Subject: Rice Solar Energy Project (09-AFC-10)
Supplementary Information Item (SII) #6
Revised General Arrangement, Rice Solar Energy Project

Attached please find one hardcopy of Rice Solar Energy, LLC's Supplementary Information Item (SII) #6 - Revised General Arrangement for the Rice Solar Energy Project (09-AFC-10).

CONCEPTUAL GENERAL ARRANGEMENT
AND OVERALL SITE PLAN

CONCEPTUAL GENERAL ARRANGEMENT OF ON-SITE ADMINISTRATION LAYOUT

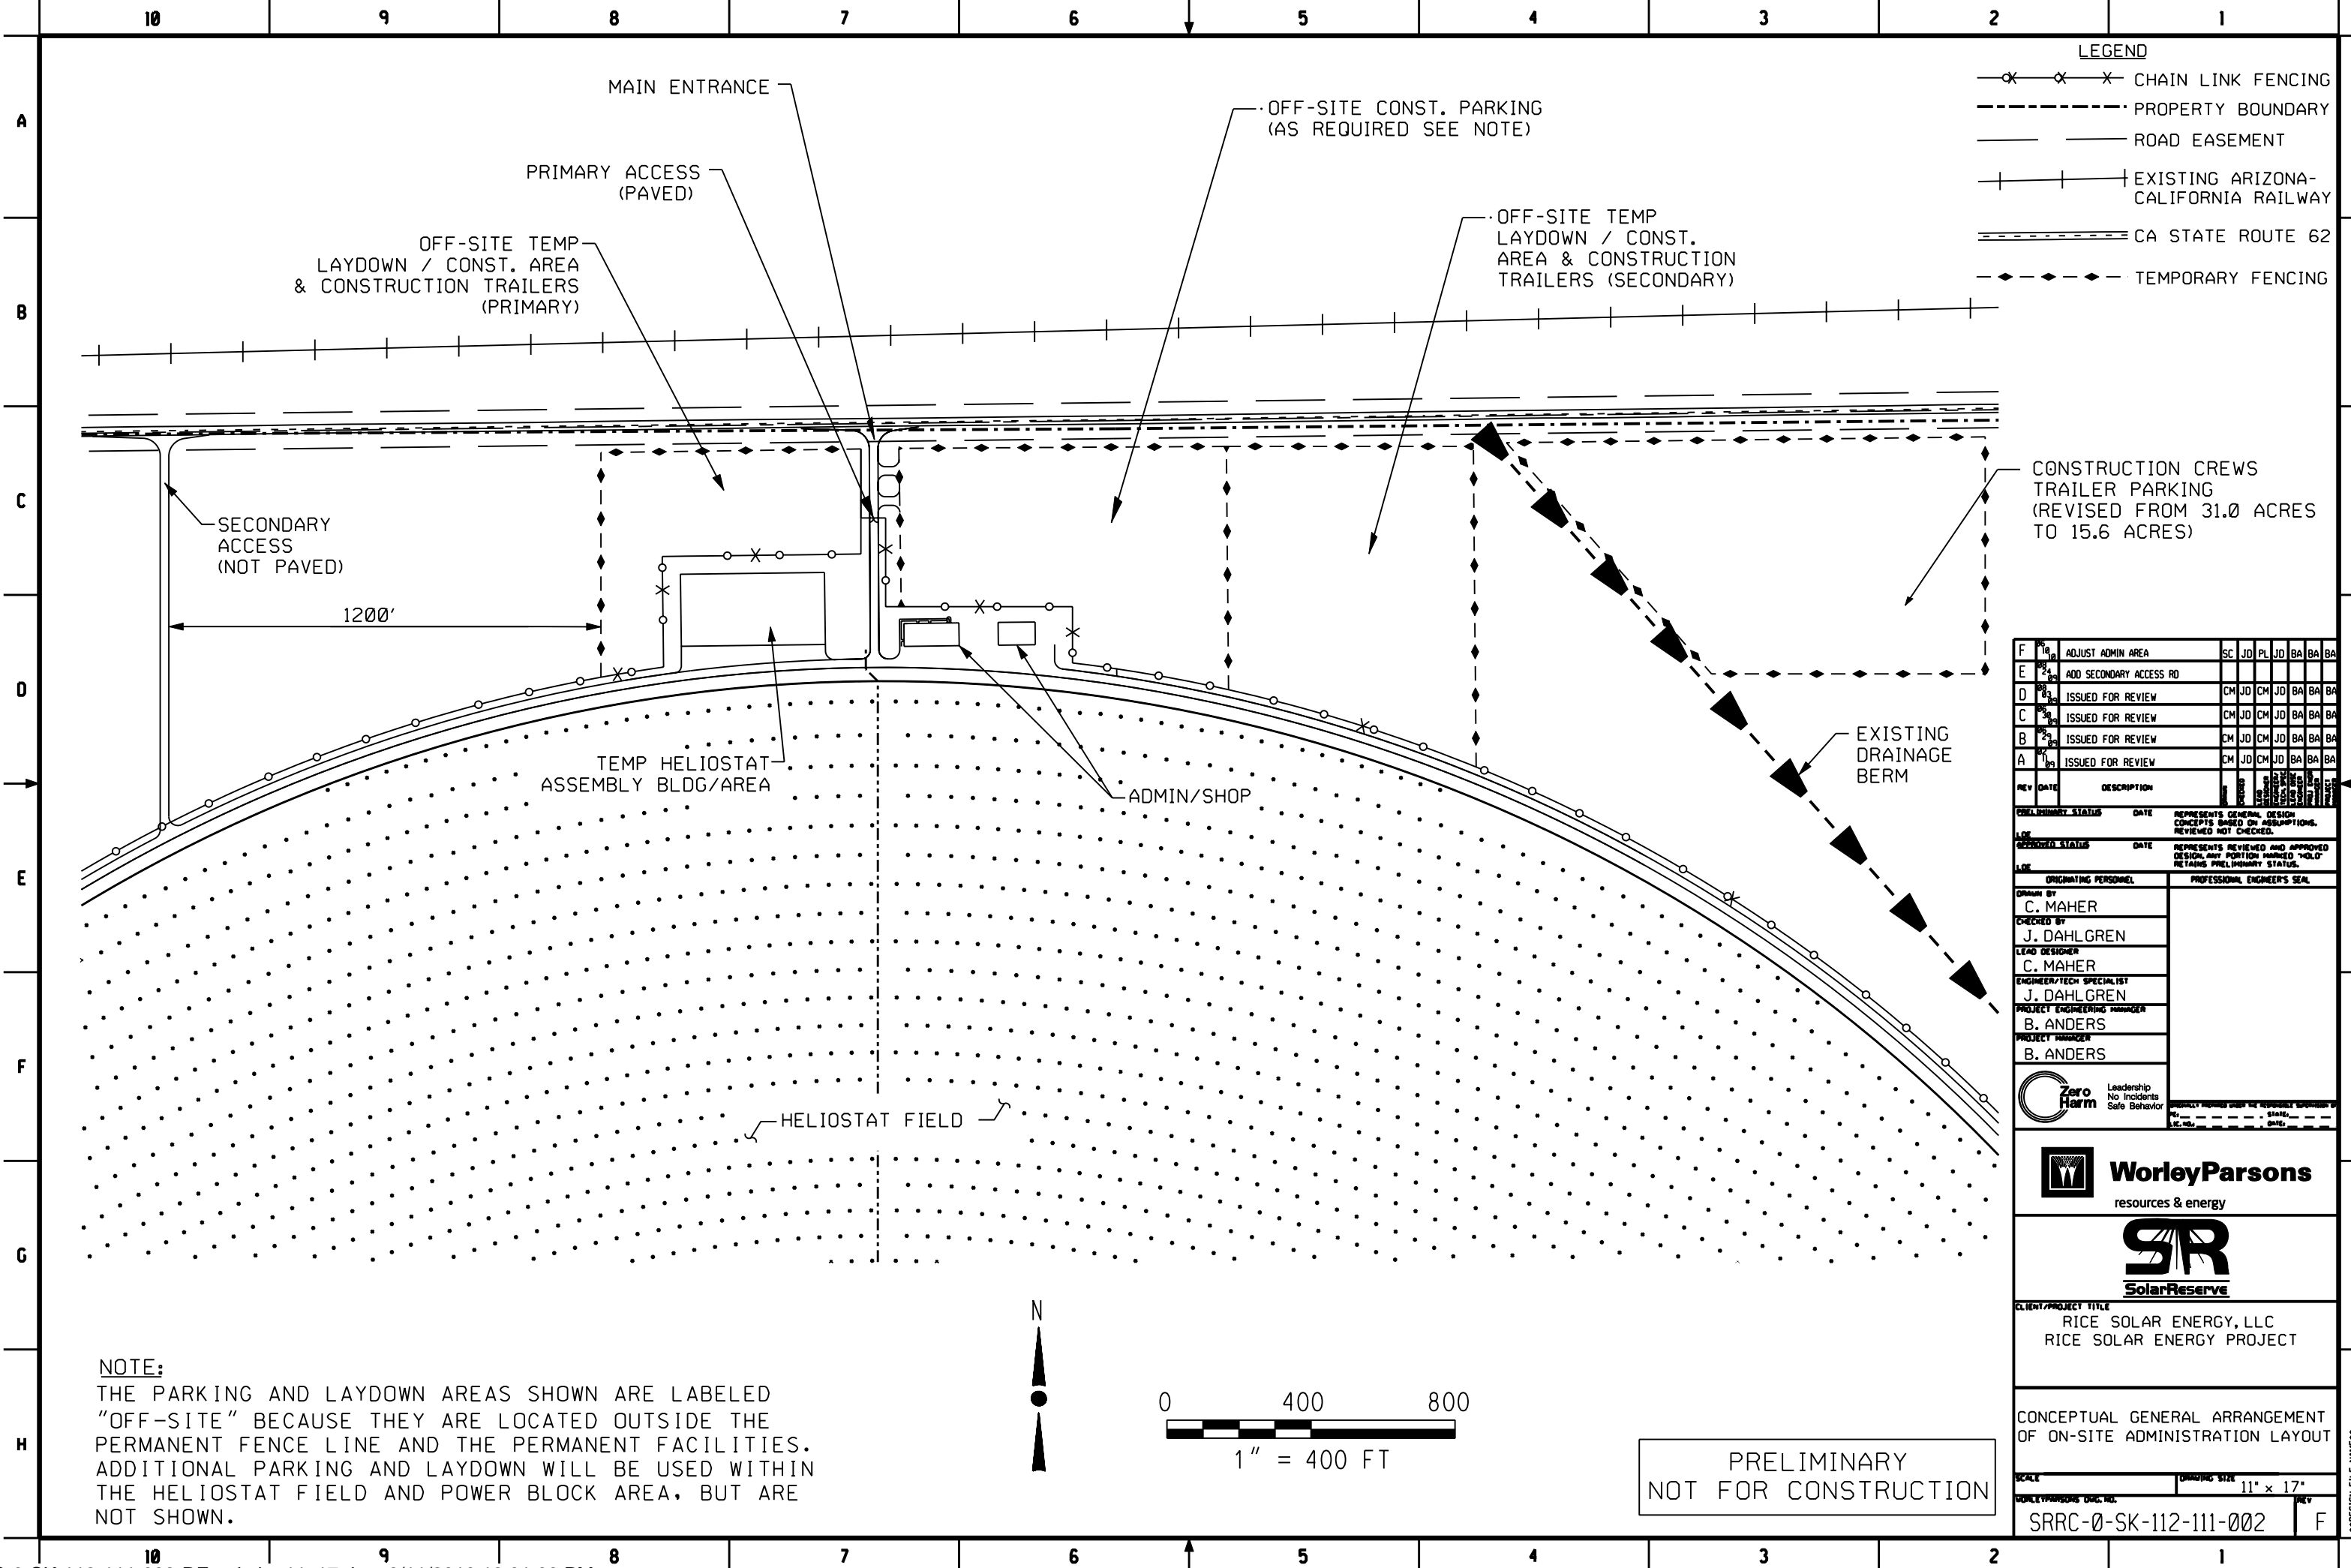
CONSTRUCTION CREWS TRAILER PARKING (REVISED FROM 31.0 ACRES TO 15.6 ACRES)

F	10	ADJUST ADMIN AREA	SC	JD	PL	JD	BA	BA	BA
E	9	ADD SECONDARY ACCESS RD	CM	JD	CM	JD	BA	BA	BA
D	8	ISSUED FOR REVIEW	CM	JD	CM	JD	BA	BA	BA
C	7	ISSUED FOR REVIEW	CM	JD	CM	JD	BA	BA	BA
B	6	ISSUED FOR REVIEW	CM	JD	CM	JD	BA	BA	BA
A	5	ISSUED FOR REVIEW	CM	JD	CM	JD	BA	BA	BA
